## Memorandum

Subject: DR-16-01 – Materials Submitted for May 17, 2016 Public Hearing

Attached are comments and applicant materials submitted on the day of or at the May 17, 2016 Historic Review Board public hearing on DR-16-01, an application for a 2-Story Mixed-Use Building at 1969 Willamette Falls Drive.

**Willamette Falls Professional Building**  
**Willamette Falls Drive & 11th Street, West Linn**

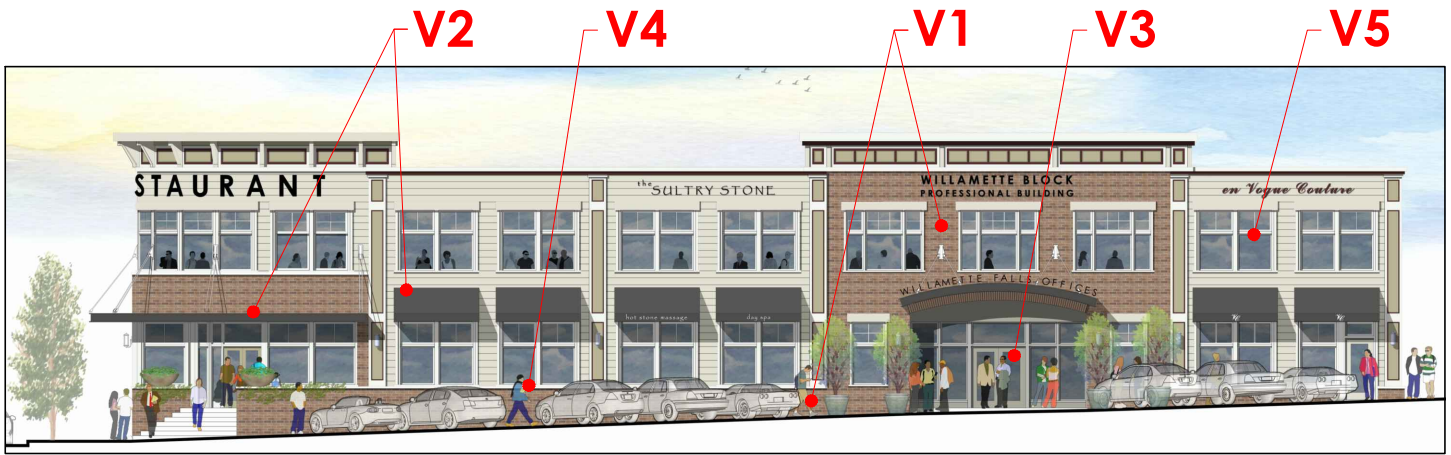
On the next page are two pictures taken from 1968 6th Avenue, which may be helpful.

View from the roof of the garage of 1968 6th Avenue. The vantage point is set back from the alley more than 20 feet; moving to the property line would provide much greater surveillance. At its shortest, the wall of the structure at the property line is less than seven feet high to the top of the gutter; the proposed structure would loom

almost four times as tall, and would not fit within this frame. The current parking is framed by pleasant landscaping. Parking off of Knapp's Alley is in full view of the master bedroom.

View from the back door of 1968 6th Avenue. The view is similar from the dining room, the kitchen, and the living room. The proposed second-story windows will have a clear view into the home. 1992 6th Avenue does not have a fence to screen the first floor view of the Knapp's Alley parking.
